The surveys were evaluated by City staff to determine if a right of way could be included as part of the minor subdivision under the current Code standards. The following evaluations were conducted to determine if there is adequate room on the site to accommodate a dedicated right of way. Evaluations focused on the survey showing the narrower, conceptual 40-foot right of way (ROW) alignment. The purpose of the evaluation is to determine if the ROW can be reserved while allowing the remaining lot area to comply with R-2 Zone dimensional requirements. The survey (see image) shows a portion of the 40-foot ROW that would intersect with Pilottown Rd. to be used for a possible road serving the proposed dwellings on parcel 335-4.00-15.00. The ROW would run between the Fishers Paradise house and the adjacent residential lot. The ROW includes a 10-foot radius at the proposed intersection, it then runs across the parcel parallel to the shared property line. The survey includes a note that states the resulting lot width of 71.44 feet would not conform to the 75-foot minimum lot width at the front yard setback line. If that were the only issue it may be possible to meet the minimum lot width b

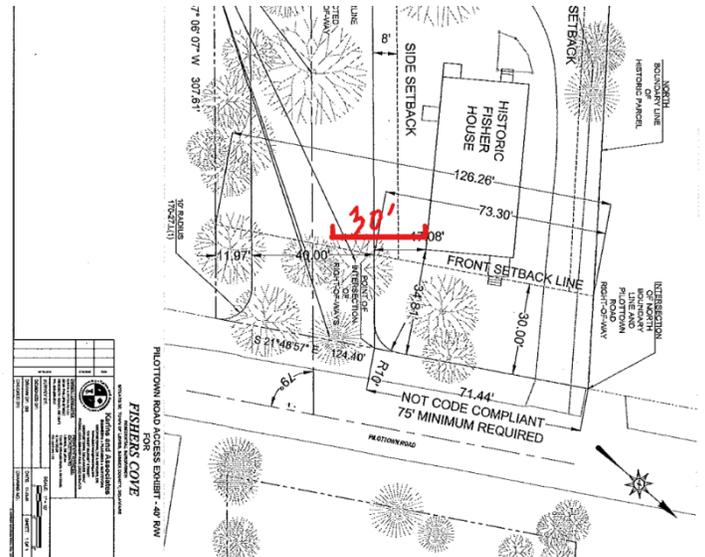
Based on these code provisions the addition of a public road to connect with Pilottown Rd. as part of the minor subdivision would make this a corner lot requiring 2 front yard setbacks of 30 feet between the parcel line and the structure. As such the 8-foot side yard setback shown on the survey would need to be changed to a 30-foot front yard setback.

Using the provided survey (see image) a 30 foot front yard setback would mean that the proposed ROW would need to shift away from the house by an additional 12.92 feet, in addition to the 17.08 feet (the current separation shown on the survey). As noted on the survey there is only 11.97 feet between the ROW and the adjacent shared property line which means there is not enough room for a 30-foot front yard setback.

According to this analysis, using the information provided in the survey, it would appear that a 40-foot or 50-foot ROW could not be incorporated into the lot since it would not be possible to meet the required front yard requirements for the R-2 Zone.

We concur with your evaluation of the Fishers House minor subdivision issue regarding a 40’ or 50’ ROW for an access road to Pilottown Road. The creation of a corner lot by accommodating an entrance street to the Fishers Cove site presents the front yard setback challenges you describe and conclude cannot be addressed while meeting the requirements for a 30’ front yard setback. Also, as you note, the City Code Section 170-27 I (1) requires a 10’ minimum ROW radius thus that radius cannot be eliminated from the design. To emphasize, you make an important point that any street ROW within the Fishers House property must adequately address impacts to the adjacent parcel – Tax Map 335-4.00 Parcel 15.01. Finally, we believe the original 20’ easement with emergency access road, walkway and potential utilities, would fit given the corner lot and its front yard setback requirements on two (2) sides. My only thought on that is whether the Fishers House parcel would be considered a “corner lot” since that 20’ is an easement and not a ROW.
